UNITED STATES PATENT AND TRADEMARK OFFICE

APPLICATION NO.	FILING DATE	FIRST NAMED INVENTOR	ATTORNEY DOCKET NO.	CONFIRMATION NO.
10/806,755	03/23/2004	Larry B. Gray	1062/C97	2422
2101	7590	04/21/2006	EXAMINER	
BROMBERG & SUNSTEIN LLP 125 SUMMER STREET BOSTON, MA 02110-1618			WEBB, TIFFANY LOUISE	
			ART UNIT	PAPER NUMBER
			3616

Office Action Summary

DETAILED ACTION

FIG. 1

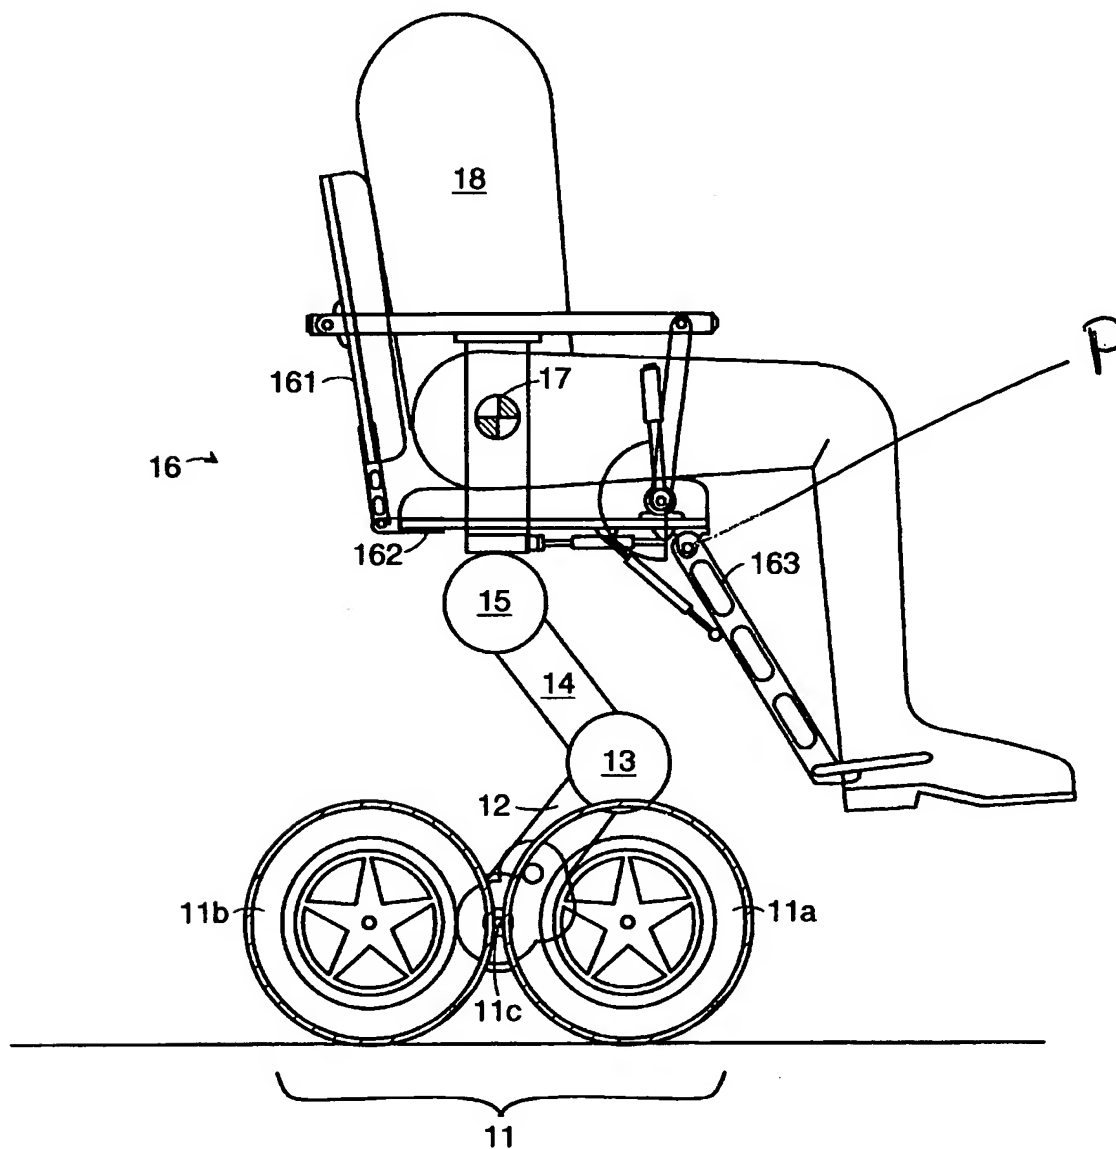
10. Claims 1-3, and 11 are rejected under 35 U.S.C. 102(b) as being anticipated by Kamen et al. (US 5,975,225). Regarding claim 1, Kamen et al. discloses having a transporter (Figure 1) for carrying a payload over a surface, the transporter including: a surface-containing module (11) for traversing the surface; a power base (col. 5, line 9), the power base pivotally coupled to the surface-containing module about a base pivot axis (11c), the base pivot axis parallel to the surface; a support (16) for supporting the payload, the support pivotally coupled to the power base about a support pivot axis (15); and a mechanical linkage for maintaining the support pivot angle constant as the power base pivots (12 and 14). Regarding claim 2, Kamen et al. discloses having a first rest (163) for partial support of the payload, the first rest pivotally coupled to the support

about a first rest pivot (see marked up copy, P), having a first rest pivot angle defined by an axis parallel to the surface and the vertical plane. Regarding claim 3, Kamen et al. discloses having a first linkage coupling the first rest to the power base in such a manner as to vary the first rest pivot angle was a function of the base pivot angle (Figures 11-15). Regarding claim 11, Kamen et al. discloses the first rest being a footrest for supporting a foot of a user (see Figure 1).
